UNITED STATES PATENT AND TRADEMARK OFFICE

APPLICATION NO.	FILING DATE	FIRST NAMED INVENTOR	ATTORNEY DOCKET NO.	CONFIRMATION NO.
10/695,849	10/29/2003	Jerome David	SPINE 3.0-414	7827
530	7590	01/30/2007	EXAMINER	
LERNER, DAVID, LITTENBERG, KRUMHOLZ & MENTLIK 600 SOUTH AVENUE WEST WESTFIELD, NJ 07090			SWIGER III, JAMES L	
			ART UNIT	PAPER NUMBER
			3733	
SHORTENED STATUTORY PERIOD OF RESPONSE		MAIL DATE	DELIVERY MODE	
3 MONTHS		01/30/2007	PAPER

Office Action Summary	Application No.	Applicant(s)	
	10/695,849	DAVID, JEROME	
	Examiner	Art Unit	
	James L. Swiger	3733

DETAILED ACTION

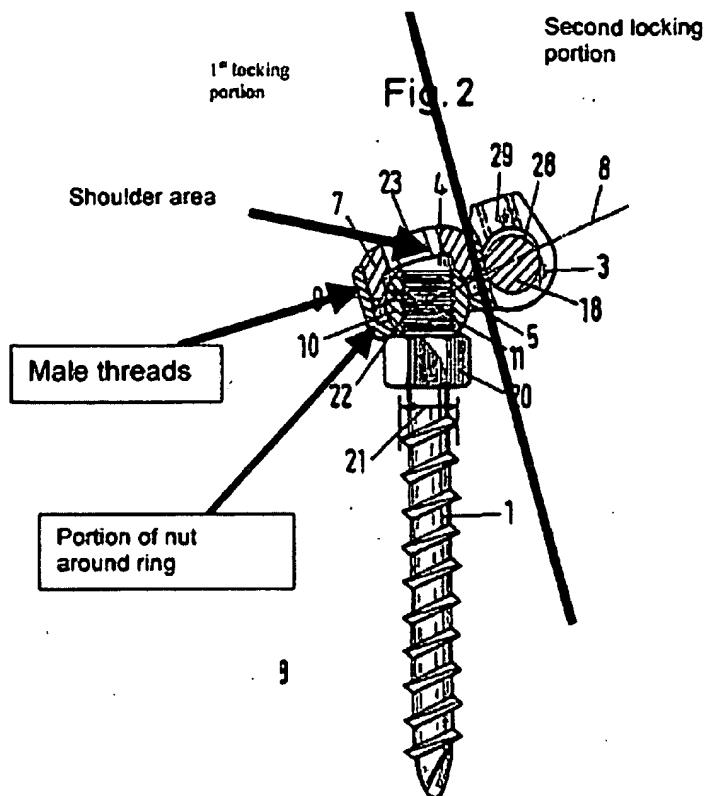
Claims 1-2, 4-5 and 7 are rejected under 35 U.S.C. 102(b) as being anticipated by Studer et al. (US 6,146,383). Studer et al. discloses a bone fixation assembly comprising what is considered a unitary coupling element (see element in Fig. 2) that permits axial and sliding movement (9) of the coupling element (1) relative to the fixation element (Figs. 1 vs. 2), and that is also adapted to receive a spinal rod (18). The bone fixation assembly also has a first locking element to secure the head portion in the first bore and a second locking element adapted to secure the spinal rod in the second bore. See drawing below.

The coupling element also comprises a locking nut (7) in the first portion, and where the first locking element comprises a ball ring (9). The second bore via the spinal rod would therefore also have an axis that is transverse to the first bore, extending coplanar in the transverse direction. Further, once the second locking element (through bore 29, and would be considered as a set screw (24)) is set into the device, it is capable of being permanent if the user chooses it to be, and would be fully secure in the connection and stabilizing the spinal rod in place. The device further comprises male threads in the first bore (see drawing above) and wherein at least a portion of the locking nut surrounds the ball ring. The male threads would inherently fit into the female threads provided on the side of the first bore. The ball ring (9) is also in contact with the coupling member portion (5) at the bottom end of the ring, and the locking nut (7) at the

top. The second locking assembly also comprises a set screw (24) that is capable of being seated in the locking member if the user wishes it to be. Also, the bottom portion of the ball ring (9) is tapered (see bottom portion of the first locking element in drawing above) to allow poly-axial motion. The fixation element also has a head portion (proximate to 22) that fits into the first locking element. Further, the ball ring and the locking nut associate with each other and with the head portion of the fixation element that is capable of exerting a radial force onto that element to secure the head of the screw in the coupling element. The set screw (24) or locking nut (7) may provide this means for providing radial forces.

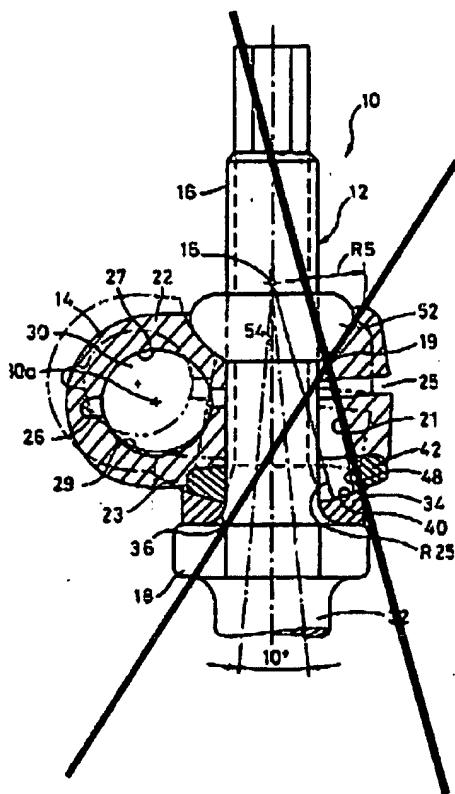
Claims 17-18 are rejected under 35 U.S.C. 103(a) as being unpatentable over the combination of Studer et al. '383 and Schlapfer et al. '684, as applied to claim 16 above, and further in view of Lange (US Patent 6,123,706). The combination of Studer et al. '383 and Schlapfer et al. '684 disclose the claimed invention except for a taper in the locking nut extending in opposite directions from that of the bore. Lange discloses a taper that is considered to go in opposing directions from the bore and to the locking nut area. See drawing below.

The lines above represent the two tapers: one from the locking nut area (upper portion) and one from the bore (lower portion). These tapers provide a means for the spinal screws to be readily adjusted when they are in use. (See Col. 1, lines 35-67). It would have been obvious to one having ordinary skill in the art at the time the invention was made to construct the bone fixation device of the combination of Studer et al. and Schlapfer et al. having at least opposing tapers in view of Lange to better allow the spinal fixation element to be adjusted in use.

FIG. 4A

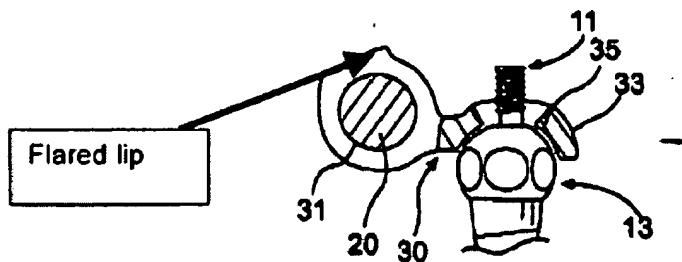
Claim 6 is rejected under 35 U.S.C. 103(a) as being unpatentable over Studer et al. '383 in view of Gu et al. (US 6,280,443). Studer et al. disclose the claimed invention except for a flared lip that cooperates with the coupling element. Gu et al discloses a taper (see drawing below) that allows for the set member bore (32) to better secure to the rod (Col. 4, lines 42-58).

It would have been obvious to one having ordinary skill in the art at the time the invention was made to construct the spinal fixation device of Studer et al. having at least a flared lip in view of Gu et al. to better secure the locking element and the rod in place and prevent the locking element from becoming removed.
